SUBJECT: AMENDMENT NO. 108 TO PROVISIONAL OPERATING LICENSE NO. DPR-20
(TAC NO. 63587)

PALISADES PLANT

Amendment No. 108
License No. DPR-20

ATTACHMENT TO LICENSE AMENDMENT NO. 108

**CONSUMERS POWER COMPANY
PLANT ORGANIZATION**

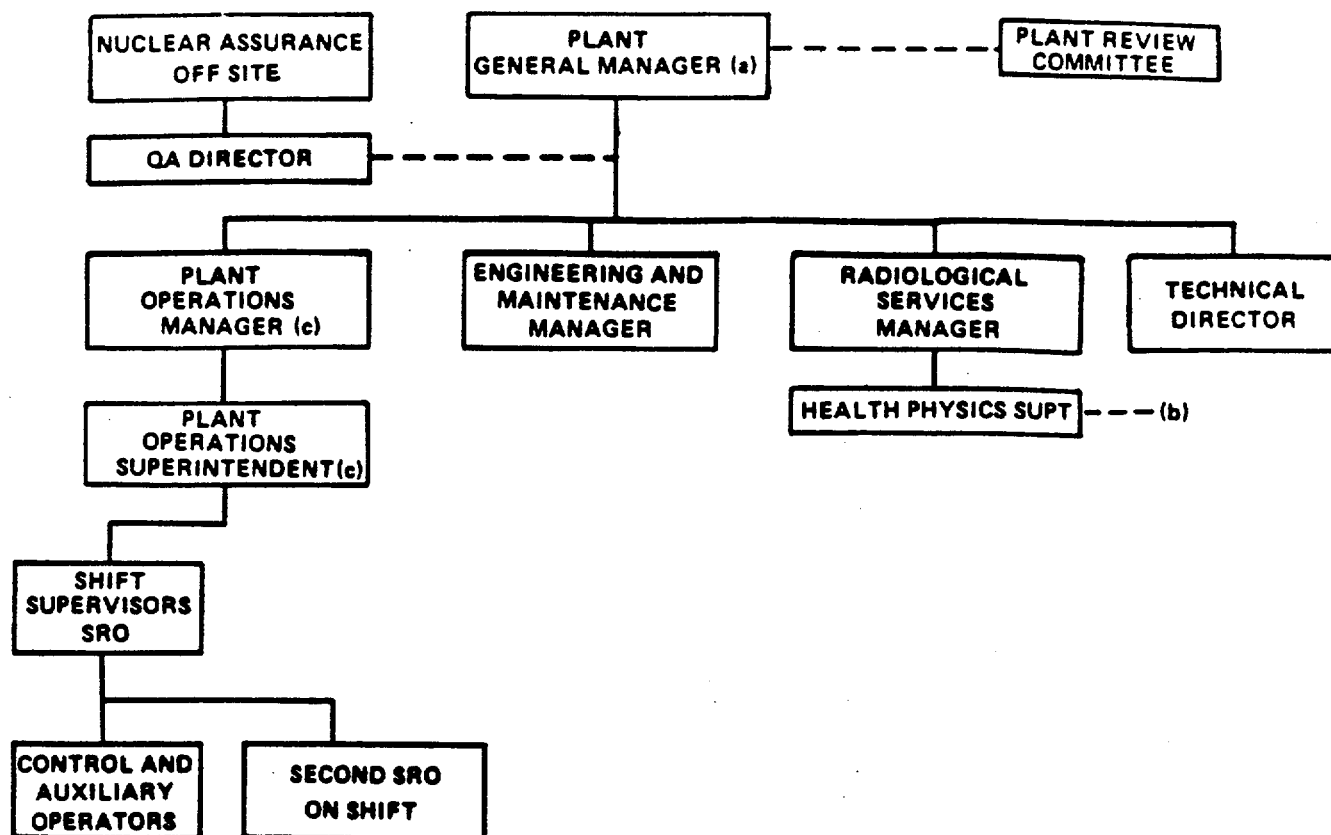
- M. The licensee has proposed changes to the plant organization, Figure 6.2-2. These changes include the titles of Generating Plant Superintendent Nuclear, Operations Superintendent and Operations Supervisor to Plant General Manager, Plant Operations Manager and Plant Operations Superintendent respectively; Health Physicist to Radiological Service Manager; deleting the positions of Maintenance Superintendent and Technical Superintendent and establishing the new positions of Engineering and Maintenance Manager, and Technical Director. These changes are acceptable as they do not delete any of the technical support to the Plant General Manager and they meet the acceptance criteria of Section 13.1 of NUREG-0800, the Standard Review Plan.

**CONSUMERS POWER COMPANY
OFFSITE ORGANIZATION**

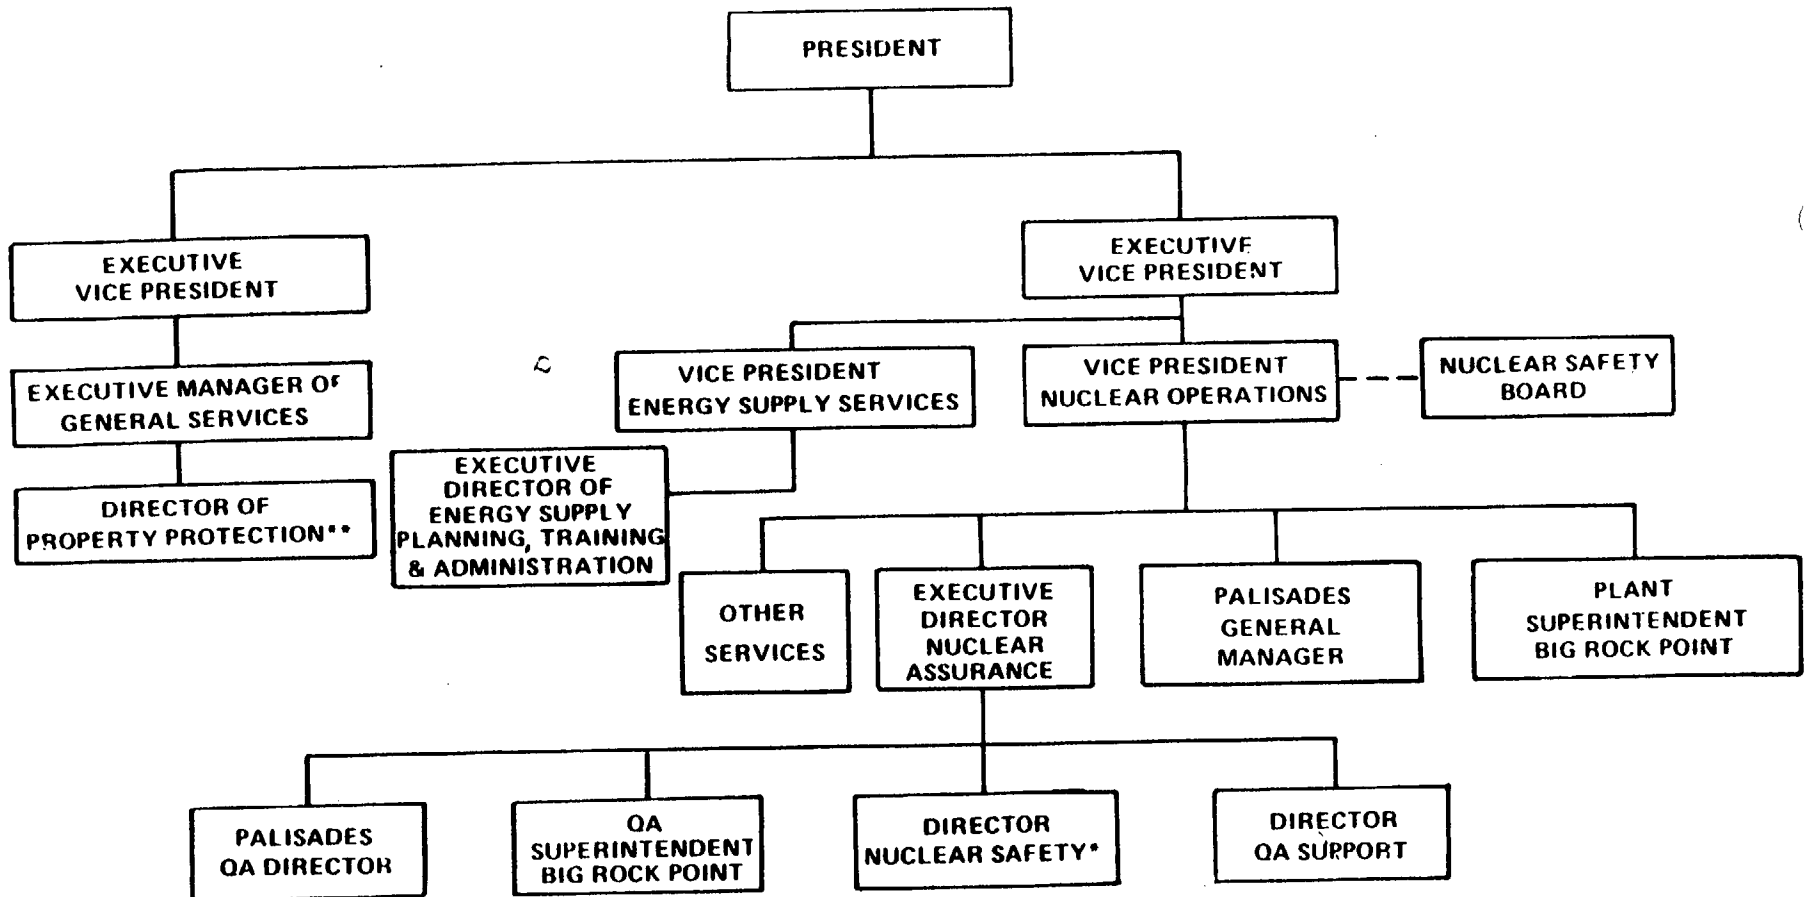
- L. The licensee has proposed changes to Figure 6.2-1. These changes are acceptable because reporting levels of safety-related functions have not been lowered and, in some cases, have been raised.
